## ORIGINATION FORM

### Proposed Revisions to a Standard Plans Index

Index Number: 700-110

Index Title: Mounting Exit Number Panels to Signs

LAST REVISION	REVISION	DESCRIPTION:	<p>FY 2022-23 STANDARD PLANS</p>	<p>MOUNTING EXIT NUMBER PANELS TO SIGNS</p>	<p>INDEX 700-110</p>	<p>SHEET 1 of 1</p>
11/01/20

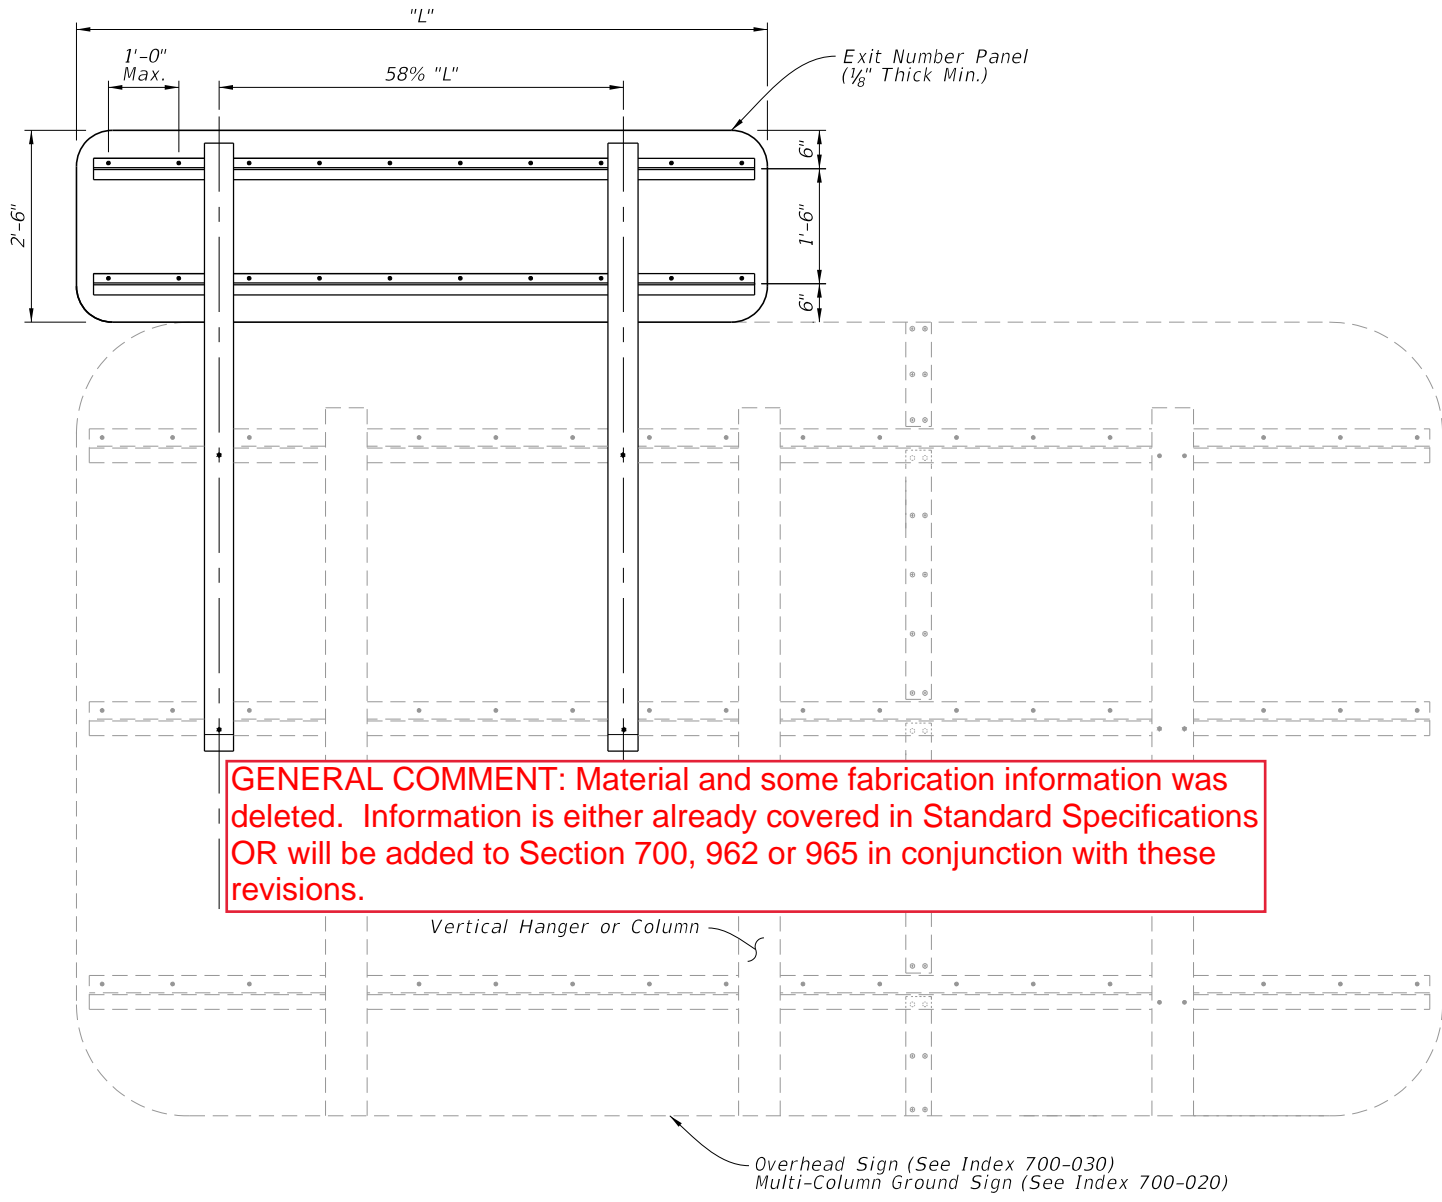
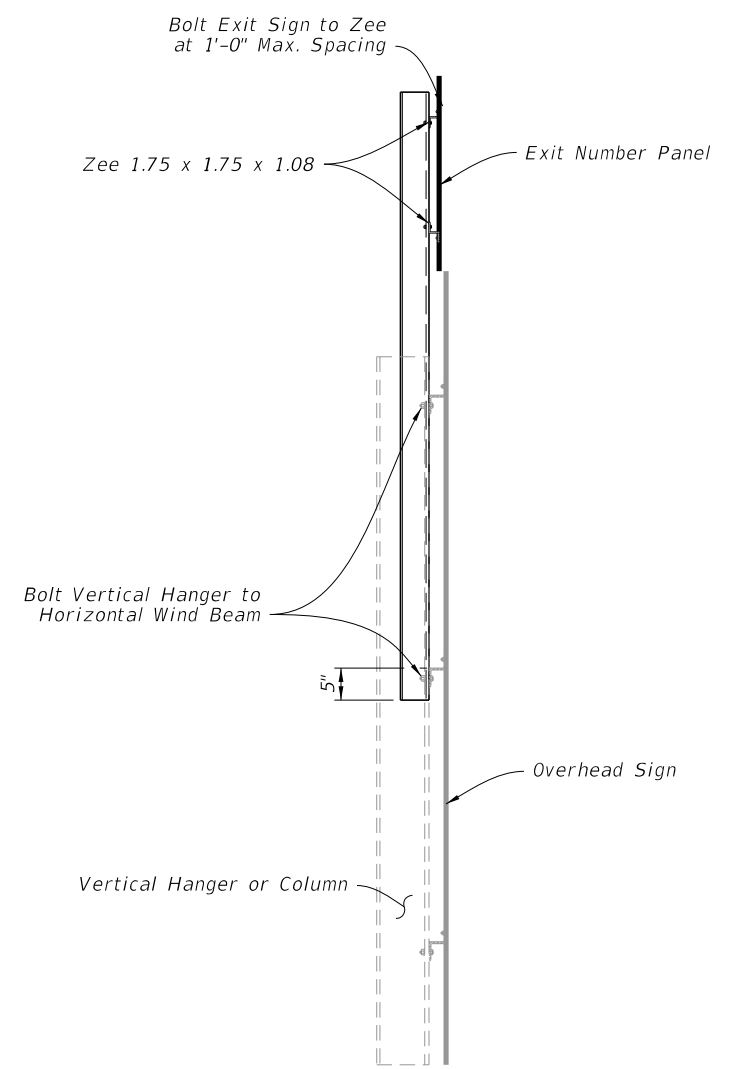
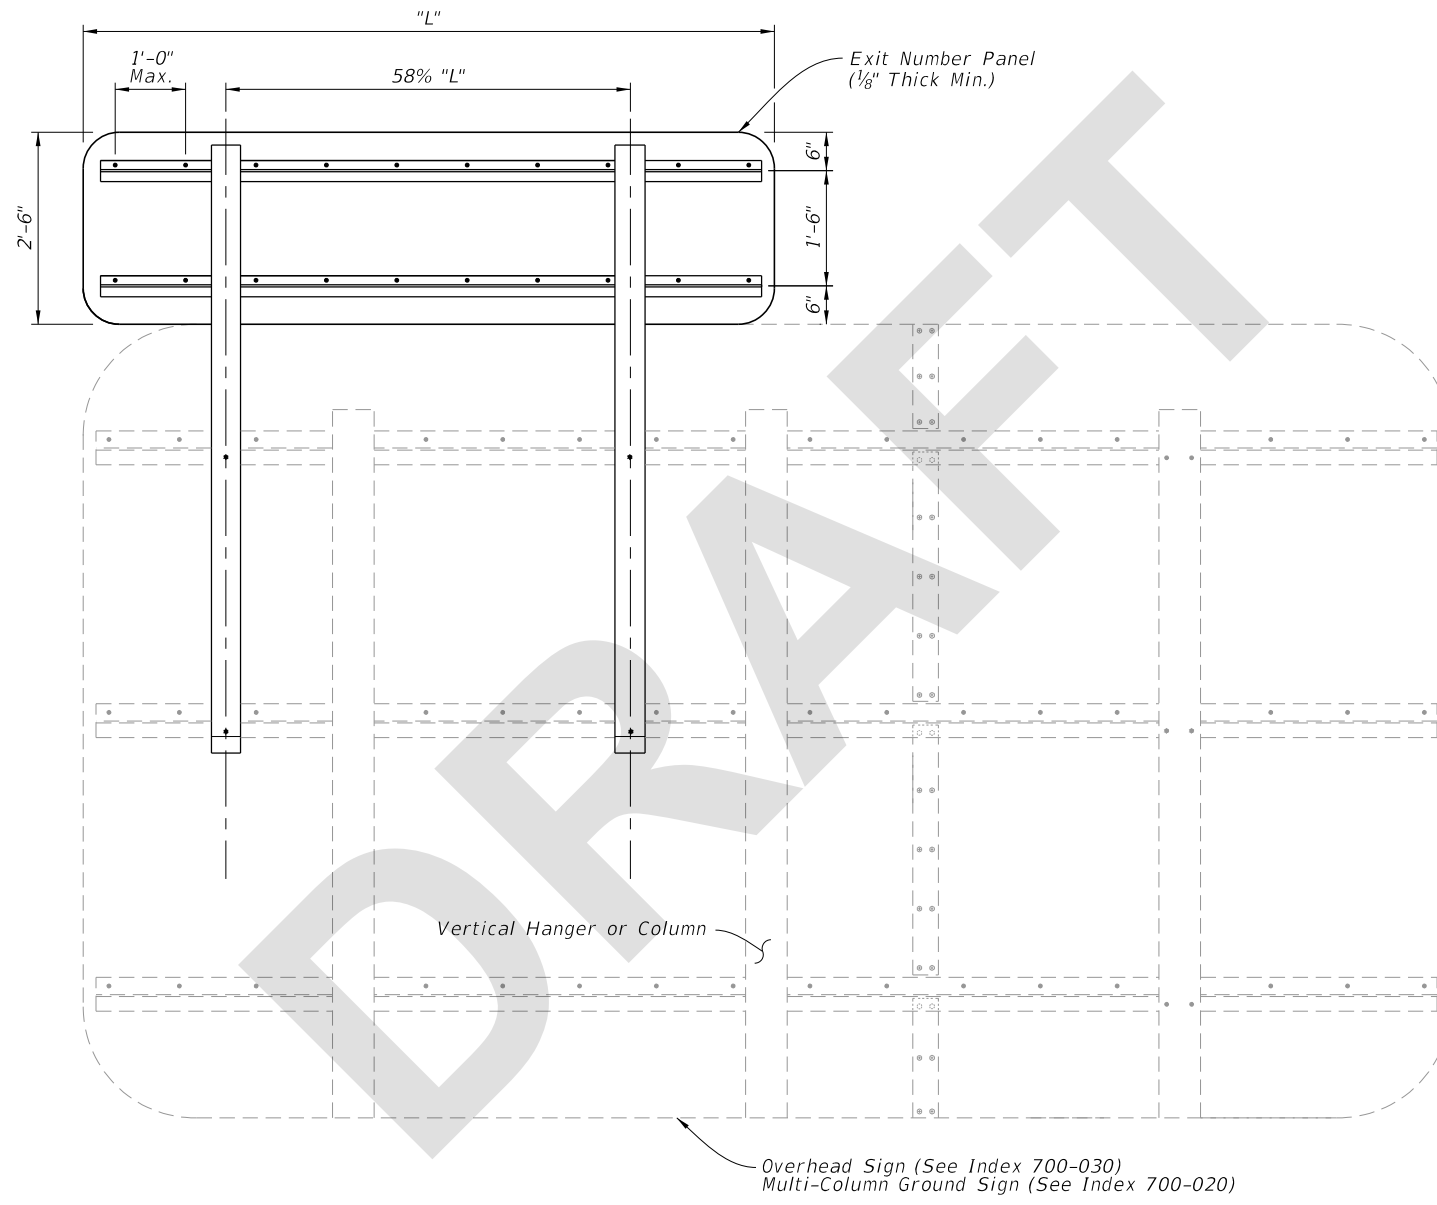
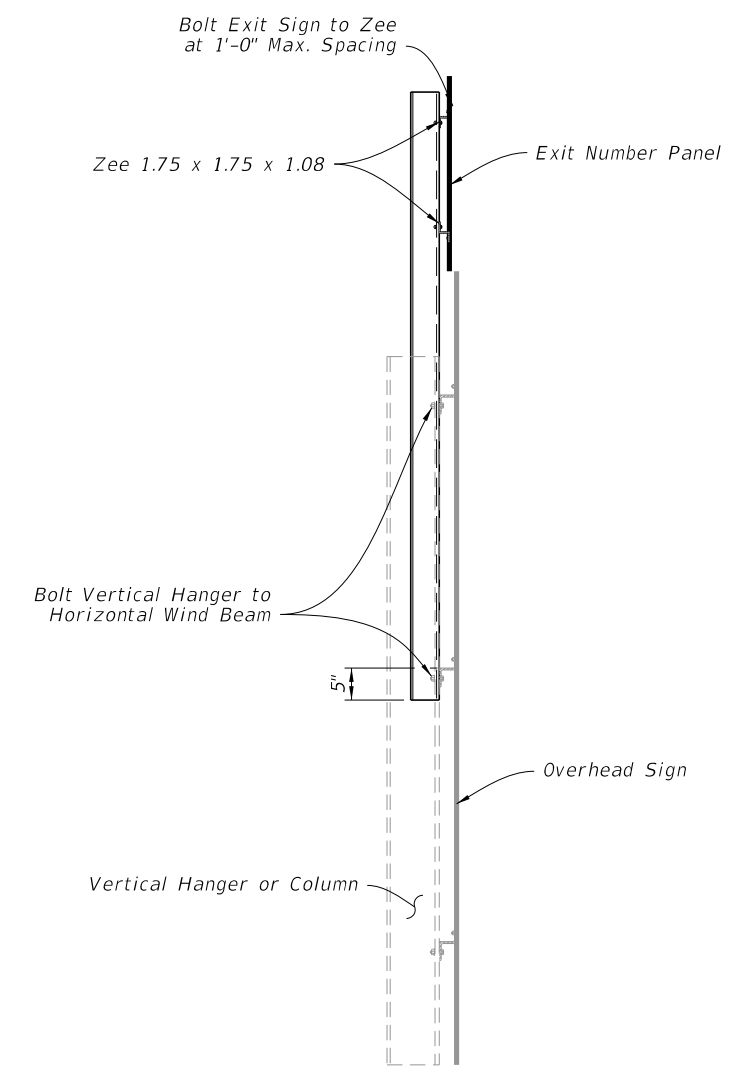
Updated Notes to General Notes; Added New General Note 1 - "Meet the requirements of Specification 700."; Deleted Note 2 and 3.B.; Renumbered General Notes.

ADDED NEW NOTE 1: Meet the requirements of Specification 700.

1. ~~NOTES:~~ UPDATED: GENERAL NOTES:

2. ~~1. Work with Indexes 700-020 and 700-030.~~
2. ~~Materials (Aluminum):~~
  - A. ~~Sheets and Plates: ASTM B209 Alloy 6061-T6~~
  - B. ~~Standard Structural Shapes: ASTM B221 Alloy 6061-T6~~
  - C. ~~Extruded Shapes: ASTM B221 Alloy 6061-T6~~
  - D. ~~For Bolts, Nuts, and Washers requirements see Index 700-020 or 700-030.~~
3. ~~Fabrication:~~
  - A. ~~See sign layout sheet for dimension "L" and sign face details in the Plans.~~
  - B. ~~Round all sign corners.~~
4. For right exits, install the Exit Numbering Panel to the top right side of the Highway Sign.
5. For left exits, install the Exit Numbering Panel to the top left side of the Highway Sign.

DELETED:

1. Meet the requirements of Specification 700.
2. Work with Indexes 700-020 and 700-030.
3. Fabrication:  
See sign layout sheet for dimension "L" and sign face details in the Plans.
4. For right exits, install the Exit Numbering Panel to the top right side of the Highway Sign.
5. For left exits, install the Exit Numbering Panel to the top left side of the Highway Sign.
